THOMAS GERLACH and DIRK DRÖGE
U.S. Patent Application S.N. 10/717,543

IN THE DRAWING:

Please amend FIG. 2 as follows:

"ANNOTATED MARKED-UP DRAWINGS"

Fig. 2

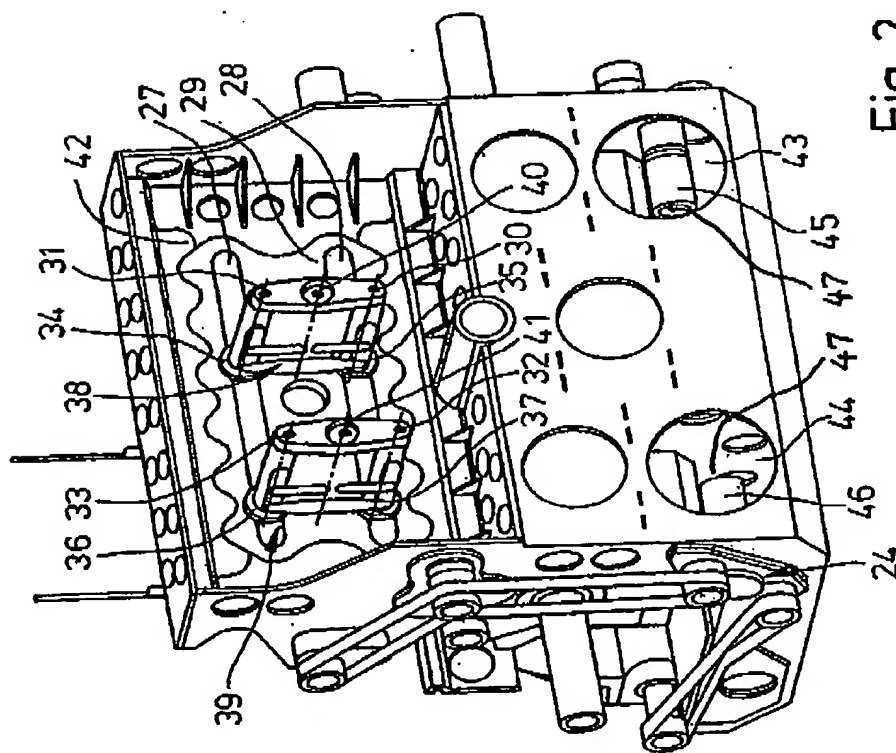
1. Please add a reference line and reference number 47 to illustrate the position sensor on drive motor 45 as indicated in red in the attached "ANNOTATED MARKED-UP DRAWINGS" of FIG. 2.

2. Please add a reference line and reference number 47 to illustrate the position sensor on drive motor 46 as indicated in red in the attached "ANNOTATED MARKED-UP DRAWINGS" of FIG. 2.

After the telephone interviews the undersigned attorney reviewed the Specification and discovered the drawing, namely FIG. 2 did not show a position sensor even though paragraph 25 and claim 10 of the Specification as originally filed claimed and described the position sensor.

Under 37 CFR § 1.83 and MPEP § 608.02(d) the drawing must show every feature specified in the claims. The original drawings, Specification and claims show the features but the claimed position sensor is not referenced in the drawing (FIG. 2). As a result FIG. 2 should be amended as well as Paragraph 0054 of the Specification to incorporate reference lines and reference numbers 47.
